Connectware™

NetSilicon
A Digi International Company

PCI Arbiter Workarounds for the NS9750

Figure 1: REQ# and IRDY# negated on same clock edge

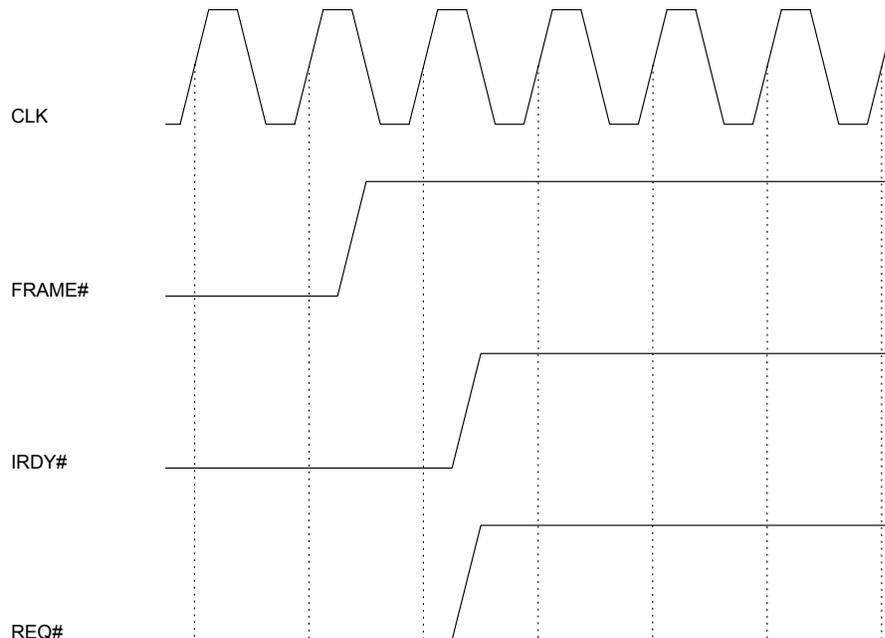
When a PCI master negates its REQ# and IRDY# on the same clock cycle, as shown in Figure 1, and no other PCI master is requesting the bus, the PCI arbiter determines that this master is still requesting the bus and grants the bus to it.

Because the master does not take ownership of the bus within 16 PCI clocks, it is considered "broken" by the arbiter and taken out of service. As a result, the PCIBRK_MX bit in the PCI Arbiter Interrupt Status register is set, indicating a "broken" master, and all further bus requests are ignored from this master until the PCIEN_MX bit in the PCI Arbiter Configuration register is toggled from low to high by software.

Some PCI devices have a bit that controls when REQ# is negated. If this bit exists, this is the preferred workaround.

Otherwise, enable the PCIBRK_MX interrupts for all masters present in the system by setting the associated EN_PCIBRK_MX bits in the PCI Arbiter Interrupt Enable register. When a "broken" master interrupt is received, the master can be re-enabled by toggling the PCIEN_MX bit for the broken master from low to high in the PCI Arbiter Configuration register.

Figure 2: Hardware workaround state diagram

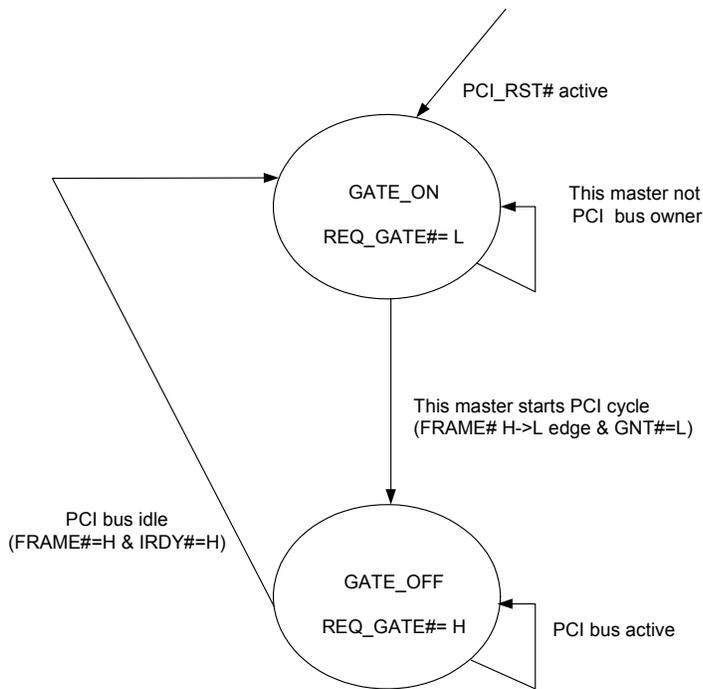
The hardware workaround is implemented as a 1-bit state machine that generates a gating signal that enables and disables the PCI REQ# from the master to the associated input of the NS9750. Figure 2 provides a state diagram.

When the state machine is in the GATE_ON state, the REQ# from the master is sent to the PCI arbiter in the NS9750. The state machine will not exit the GATE_ON state until this master has taken ownership of the PCI bus. Ownership of the bus is detected on the first clock cycle that this master drives FRAME#.

When the bus takes ownership, there is no reason to keep the REQ# from this master asserted with the bus-parking arbitration scheme described above, and it is forced inactive to the NS9750 when the state machine transitions to the GATE_OFF state. The state machine remains in the GATE_OFF state until the PCI bus goes idle, when it is safe to enable the REQ# again.

Figure 3: Hardware workaround sample implementation

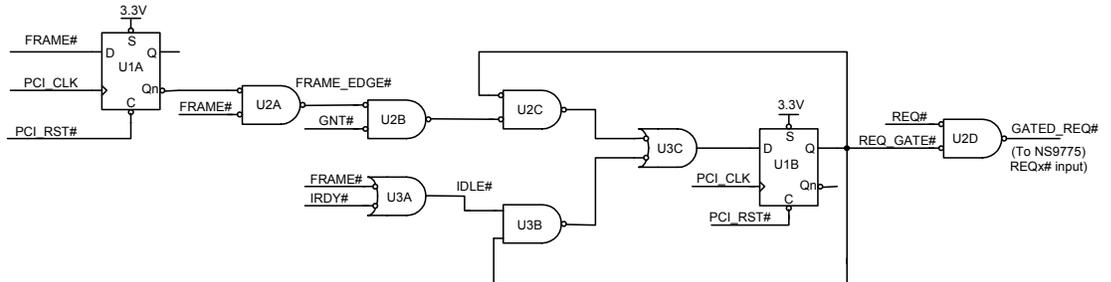
Figure 3 shows a sample implementation. This implementation uses only 2-input logic gates. Implementations that use gates with more inputs would result in fewer levels of logic. Also, all the combinatorial logic could be implemented using spare resources in an already existing PLD or FPGA in the target application. Timing must be met in whatever implementation is chosen.

Another path exists from U1A-Qn, but this is not a concern because the PCI_CLOCK skew between U1A and U1B is insignificant. Also the feedback path from U1B-Q is not a concern because it would satisfy the 0ns hold requirement of the 74LVC74 without any gate delays.

Notes:
 U1A, U2A, and U3A are common to additional gating circuits.
 FRAME_EDGE# detects the H->L edge of FRAME#.
 U2 is a quad-OR gate; U3 is a quad-NAND gate.
 PCI_CLK for U1A and U1B is from the same driver.
